Attachment 1

Revised Technical Specification Page 3/4 4-26

FIGURE 3.4-1

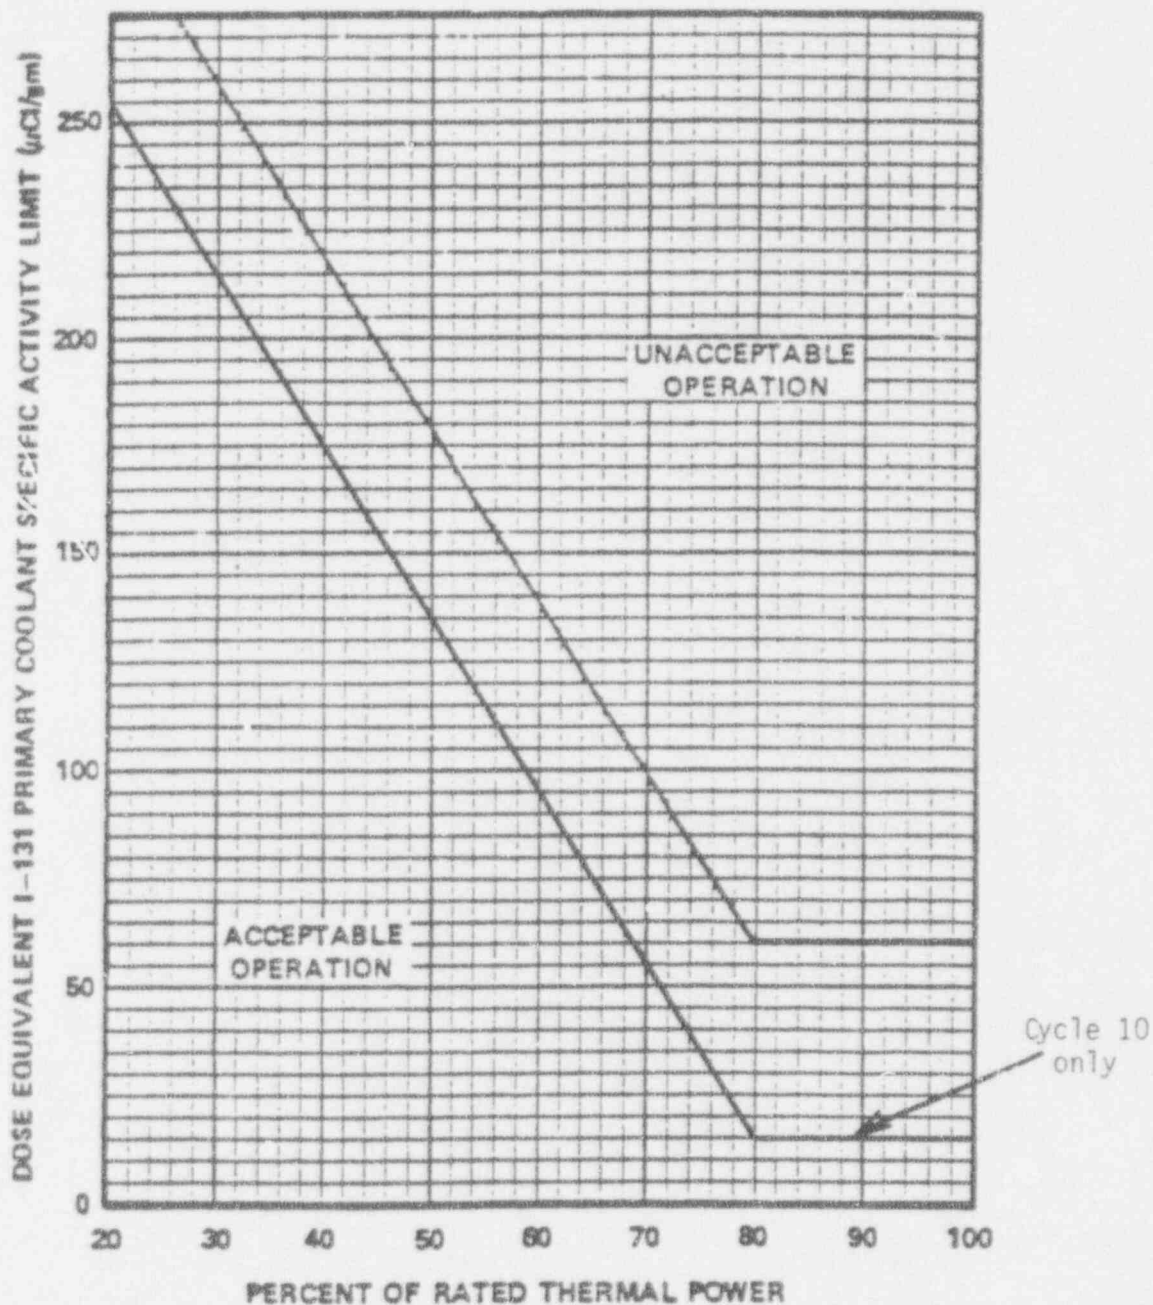
(Activity $> .25 \mu\text{Ci/gram}$ Dose Equivalent I-131 for Cycle 10 only.)
